V2500-A1/A5/D5 SERIES PROPULSION SYSTEMS SERVICE BULLETIN

This document transmits Revision 1 to Service Bulletin EV2500-72-0411

Reason for change
To add visual inspection
instead of evacuation check
for Front Bearing
Compartment without the
Leak Check Fixture. To add
scallop type for the oil
drain feature at the side
wall of Hydraulic Seal
groove for new production.

ENGINE – LP COMPRESSOR – INTRODUCTION OF HYDRAULIC SEAL WITH REVISED OIL DRAIN
FEATURE

Before and after alteration of hydraulic seal
Fig.1

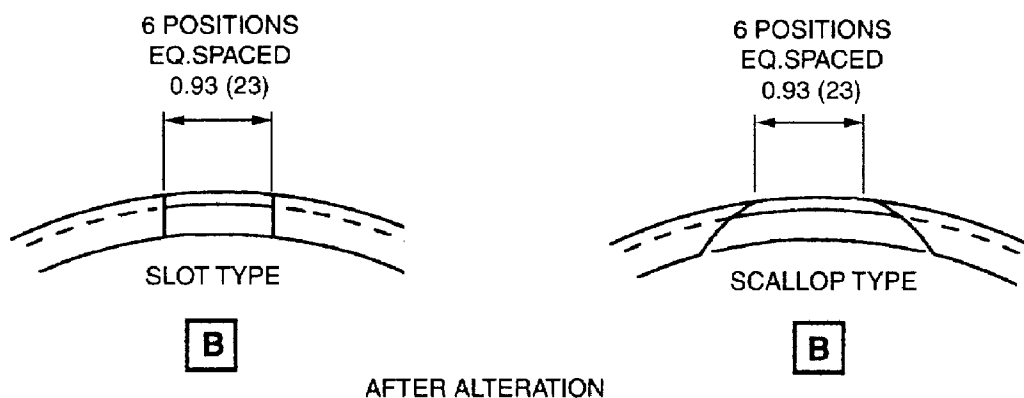
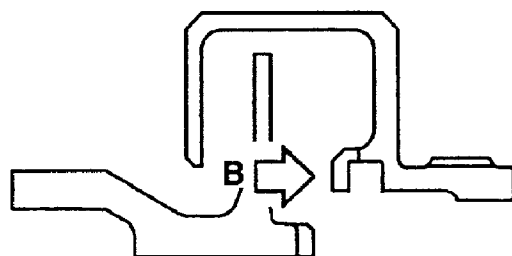
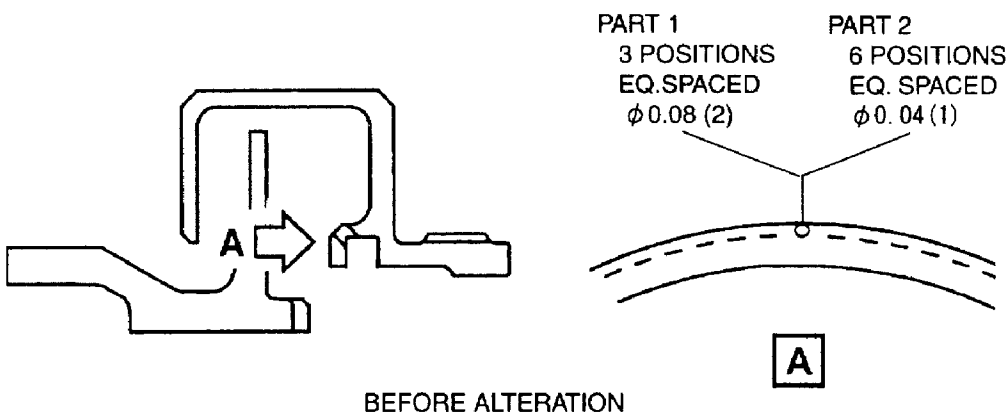
R (a) The oil drain feature at the side wall of hydraulic seal groove is
changed from holes to slots or scallops. Refer to Fig.1.

(b) The numbers of the oil drain feature are not changed. Refer to Fig.1.

R (c) The oil drain feature at the side wall of hydraulic seal groove is
changed from holes to slots or scallops. Refer to Fig.1.

(d) The numbers of the oil drain feature are changed from three to six.
Refer to Fig.1.

NOTE: THERE ARE TWO TYPE, SLOT TYPE OR SCALLOP TYPE
FOR OIL DRAIN FEATURE OF AFTER ALTERATION

Installation of hydraulic seal to tool IAE3J12858 fixture, machining hydraulic seal
Fig.4

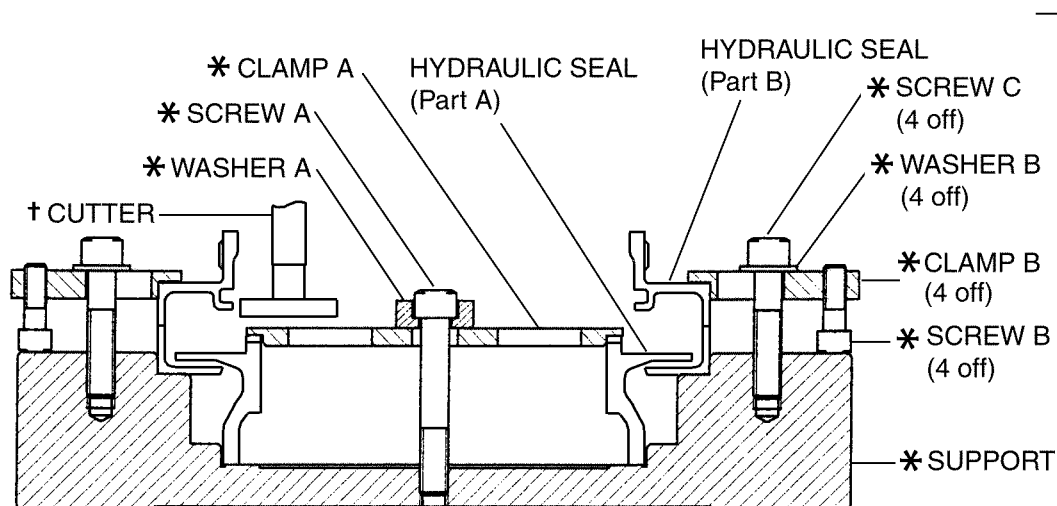
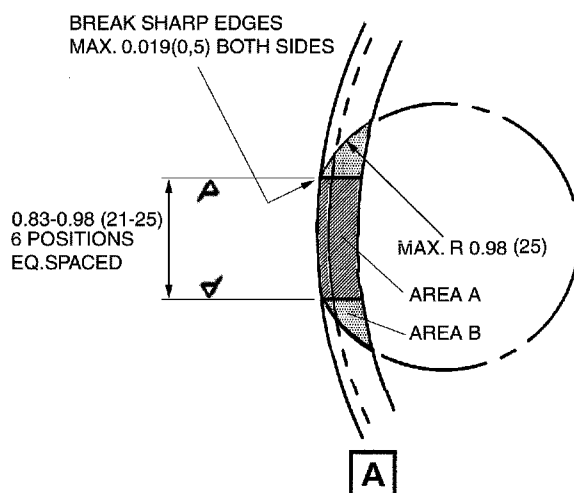
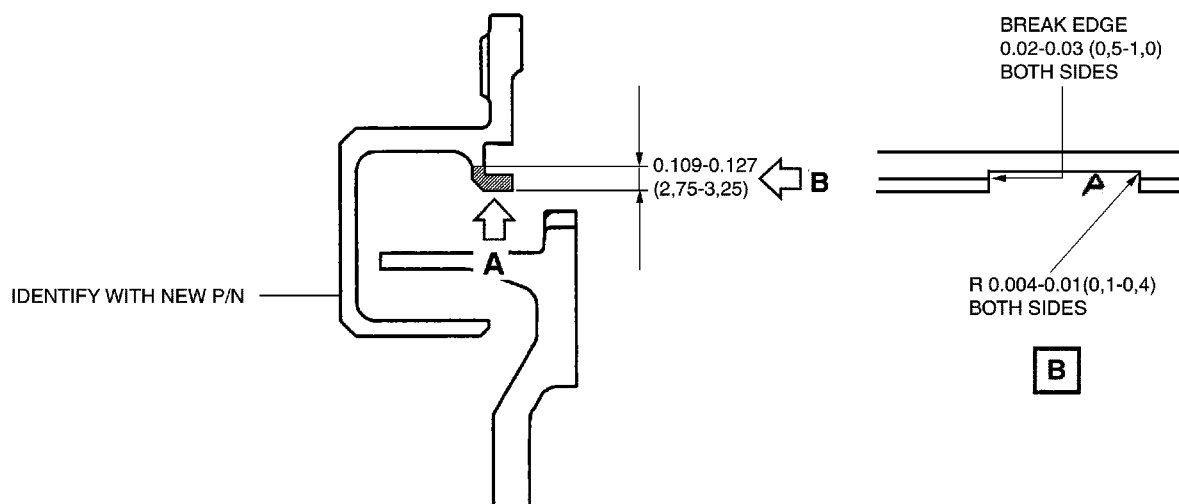
- (i) Put the hydraulic seal (Part A and Part B) on the special tool
- (ii) Adjust position of clamps B to seat clamps B to the hydraulic seal (Part B) and safety the hydraulic seal (Part B) with the four screws C, washers B, clamps B and screws B

- (iii) Safety the hydraulic seal Refer to Fig.4.
(Part A) with the screw A,
washer A and clamp A

Rework and re-identification of seal, A/O hydraulic
Fig.5

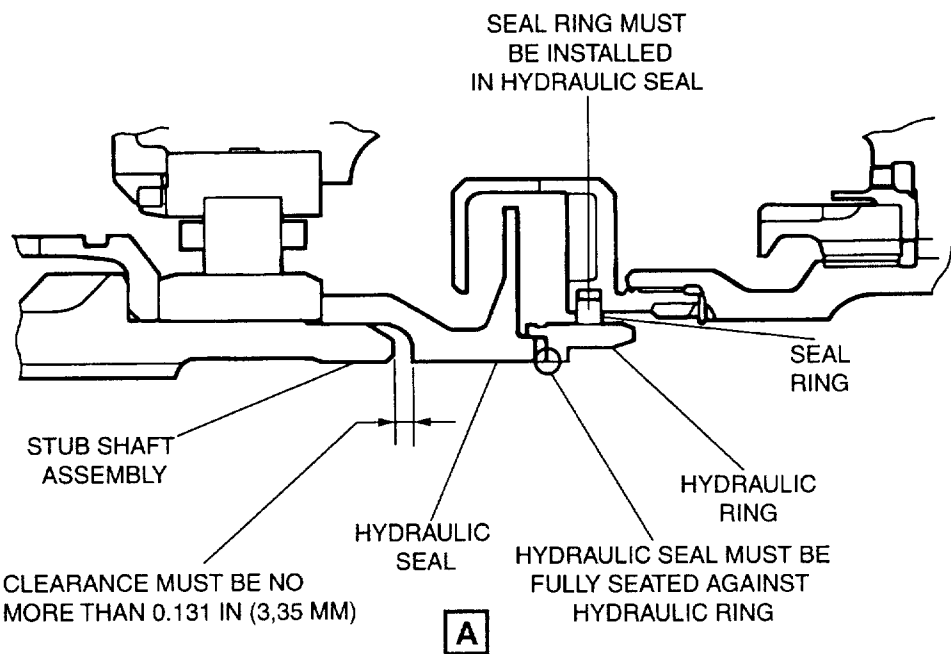
- (b) Cut out the side wall of Refer to Fig.5. Use standard workshop
groove at six equally spaced equipment
positions on circumference of
hydraulic seal

NOTE: All existing drain holes
have to be removed
completely by new cut
off areas.

NOTE: Machining operation is
mandatory at area A.

NOTE: Machining operation is not
mandatory at area B.

- (c) Remove all burrs and sharp Refer to Fig.5
edges from areas cut out

- (d) Examine dimensions Refer to Fig.5

- (e) Cancel existing part number Use vibro-peen method. Refer to Fig.5
and identify with new part and SPM 70-09-00, Marking of Parts,
number adjacent to existing TASK 70-09-00-400-501.
part number

ALL DIMENSIONS ARE IN IN.(MM)
ALL EXISTING DRAIN HOLES HAVE TO BE REMOVED
COMPLETELY BY NEW CUT OFF AREAS.
MACHINING OPERATION IS MANDATORY AT AREA A.
MACHINING OPERATION IS NOT MANDATORY AT AREA B.
SURFACE ROUGHNESS WHERE MARKED ✓
TO BE 250 MICROINCHES (6,3 MICROMETER).

Requirements of Visual Inspection
Fig.6

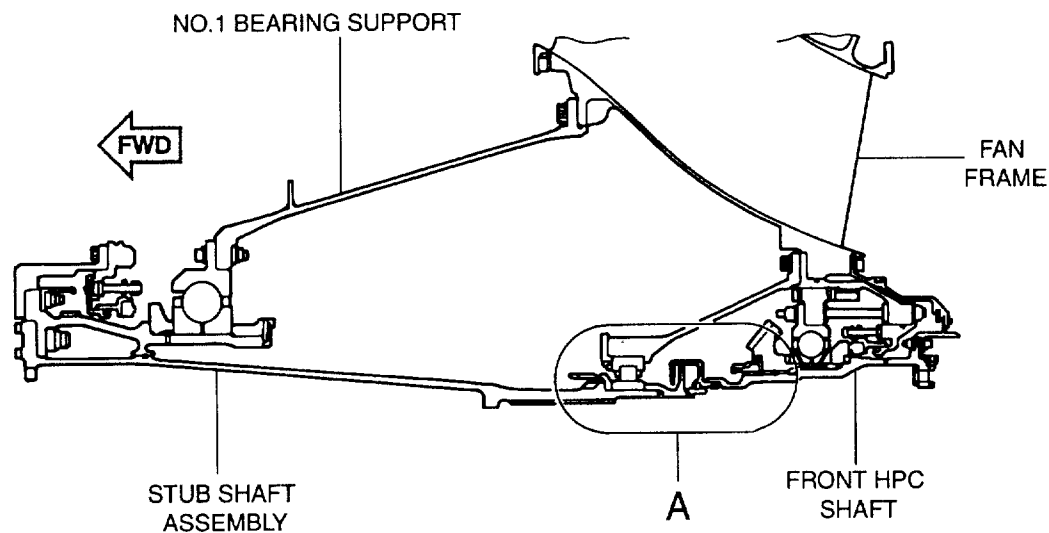
- R Evacuation check for front bearing compartment without the Leak check
R fixture in the Stub Shaft Assembly and the Hydraulic Seal is not required.
- (2) Visually inspect the Stub Shaft Assembly, Hydraulic Seal and Hydraulic Ring. Refer to following procedure and Figure 6.

- R (a) Make sure the clearance between the Stub Shaft Assembly and the
R Hydraulic Seal is no more than 0.131 in. (3,35 mm.). If the clearance
R is over 0.131 in. (3,35 mm.), reject the module.

- R (b) Make sure the Hydraulic Seal is fully seated against Hydraulic Ring.
R If Hydraulic Seal is not seated, adjust position of Hydraulic Ring.
R Refer to EM, 72-32-00, Assembly-06

- R (c) Make sure Seal Ring is installed in Hydraulic Seal. If Seal Ring is
R not installed, reject the module.
